Access Compliance Report

Public Rights-of-Way

Intersection ID: 2985	Main Street: WOODFIRE_RD	Cross Street: YELLOW_ROSE_LN	Location: NW
ADA ID: DD549E51F134	Ramp Type: Perp	Initial Pass/Fail: Fail	Overall Compliance: No
		Severity Score: 12.5

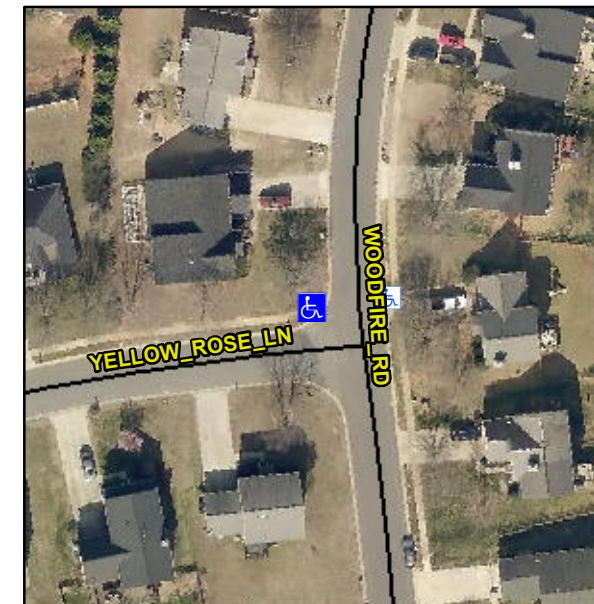
Not Found, R304.2.2

Compliance	Description	Data	Compliance	Description	Data
N/A	Ramp Length (in)	48.0	No	Ramp Slope (%)	10.4
Yes	Ramp Width (in)	48.0	Yes	Ramp XSlope (%)	1.1
N/A	Flare Type LT	N/A	N/A	Flare Type RT	N/A
N/A	Flare Slope LT (%)	N/A	N/A	Flare Slope RT (%)	N/A
N/A	Flare Traversable LT?	N/A	N/A	Flare Traversable RT?	N/A
N/A	Landing Length (in)	N/A	N/A	DWS Provided?	N/A
N/A	Landing Width (in)	N/A	N/A	DWS Contrast?	N/A
N/A	Landing Slope (%)	N/A	N/A	DWS Length (in)	N/A
N/A	Landing X Slope (%)	N/A	N/A	DWS Full Width?	N/A
N/A	Landing Curb? (Y/N)	N/A	N/A	DWS Offset (in)	N/A
N/A	Shared Landing?	N/A			
N/A	Gutter Ponding?	N/A	N/A	Gutter Slope (%)	N/A
N/A	Gutter Lip Ht (in)	N/A	N/A	Gutter X Slope (%)	N/A
N/A	Painted X Walk1?	No	N/A	Painted X Walk2?	N/A
	X Walk 1 Direction	To E		X Walk 2 Direction	N/A
N/A	X Walk 1 Width (in)	N/A	N/A	X Walk 2 Width (in)	N/A
	X Walk 1 Slope (%)	1.7		X Walk 2 Slope (%)	N/A
	X Walk 1 X Slope (%)	3.3		X Walk 2 X Slope (%)	N/A

Remove & Replace Entire Ramp.
